**SUSTAINABLE DEVELOPMENT
DIRECTORATE
APPENDICES
BOOK 2
Appendices: 12.2.3D – 12.2.4
ORDINARY COUNCIL MEETING**

(Appendix ORD: 12.2.3D)

SCHEDULE OF PUBLIC SUBMISSIONS

DEAG Submission on Cleanaway Development Application

Figure 1 Map showing Faultline

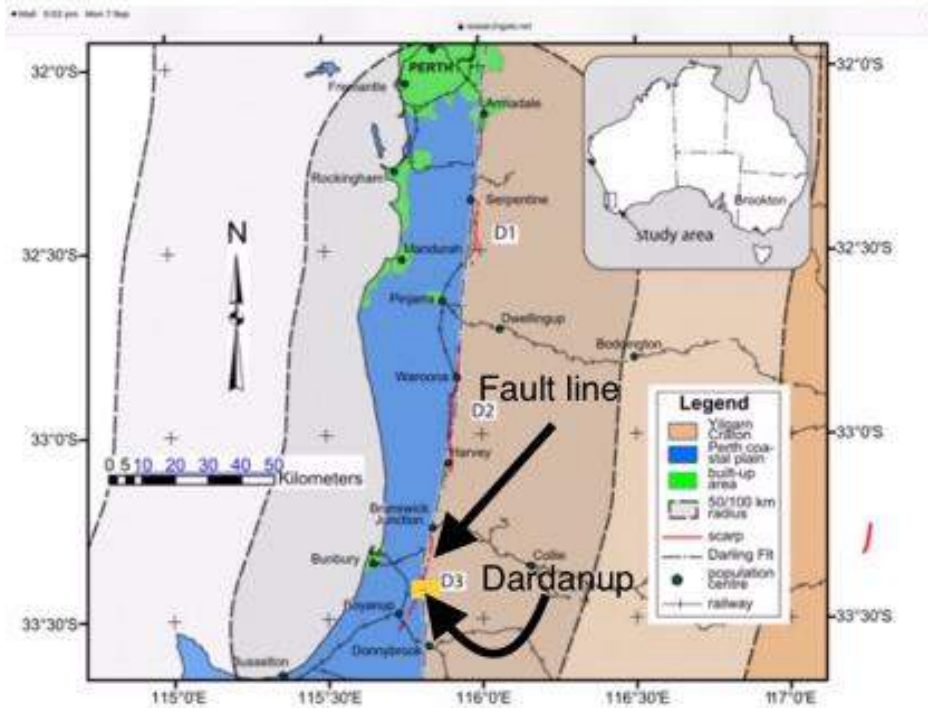
- *Mound landfills are to be avoided as their exposed nature requires significant litter controls and present a significant visual impact on the landscape*
- *Landfills must not be located in areas of potable groundwater, groundwater recharge areas or in areas identified as Public Drinking water Protection Areas*
- *A reasonable degree of assurance of long-term protection of the landfill from earthquakes is to avoid sites within 100 metres of a fault line. The facility is located on the Darling Fault Line (see Figure 3)*

Figure 2: Drawing BANK SK58

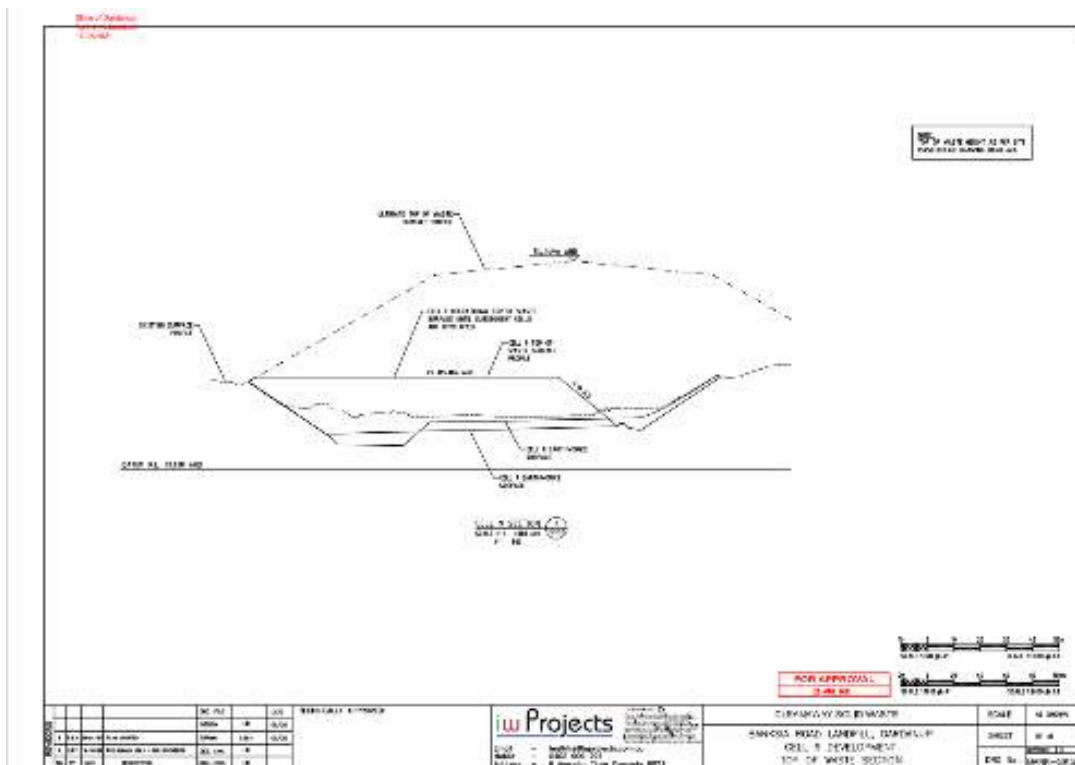
This claim of “discrete” and hidden from view is completely incorrect. See Drawings DARD-620 & 621 (Development

Application Appendix B Attach-3-Dard-621-diagram.pdf) and BANK SK58 (Development Application Appendix B Attach-5-Cell-9-Top-of-Waste-Section.pdf).

DARD_620 & 621 are plan drawings showing the contours, elevations and slope after completion of Cells 8,9 & 12 A and at final completion. BANKSK58 (Figure 2 is an elevation drawing and shows the final Top of Waste

These drawing indicate that the final mound will be just over a kilometre long and 600m wide, with the top 600m x 150m (as wide and four times as long as Optus Stadium). It is hard to image how much this will dominant the landscape and impact on the visual amenity, not just surrounding the site, but for kilometres.
